·	Application No.	Applicant(s)
Notice of Allowability	10/698,266	WENSTRUP ET AL.
	Examiner	Art Unit
	Vinh T. Luong	3682
The MAILING DATE of this communication apperall claims being allowable, PROSECUTION ON THE MERITS IS herewith (or previously mailed), a Notice of Allowance (PTOL-85) NOTICE OF ALLOWABILITY IS NOT A GRANT OF PATENT RI	(OR REMAINS) CLOSED in or other appropriate communi GHTS. This application is su	this application. If not included nication will be mailed in due course. THIS

Application/Control Number: 10/698,266

IIILE Bolted Pilot Web with...
S.N. 10/698,266 File: 1-16404

Fig 4

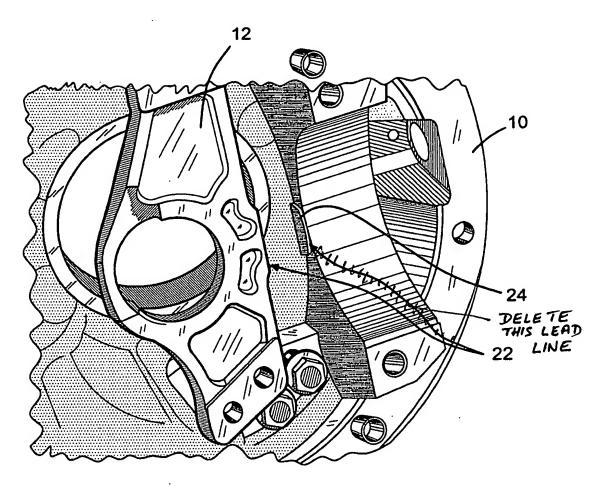
- 1. The Amendment filed on August 9, 2006 has been entered.
- 2. The drawings were received on August 9, 2006. These drawings are accepted by the Examiner subjected to the amendment below.
- 3. An examiner's amendment to the record appears below. Should the changes and/or additions be unacceptable to applicant, an amendment may be filed as provided by 37 CFR 1.312. To ensure consideration of such an amendment, it MUST be submitted no later than the payment of the issue fee.
- 4. The following changes to the drawings have been approved by the examiner and agreed upon by applicant as seen in attached sheets:
- (a) In Fig. 2, add the referential numeral 22 to indicate the first stop claimed in claim 1; and
- (b) In Fig. 4, delete the lead line from the referential numeral 22 to the second stop 24.

In order to avoid abandonment of the application, applicant must make these above agreed upon drawing changes.
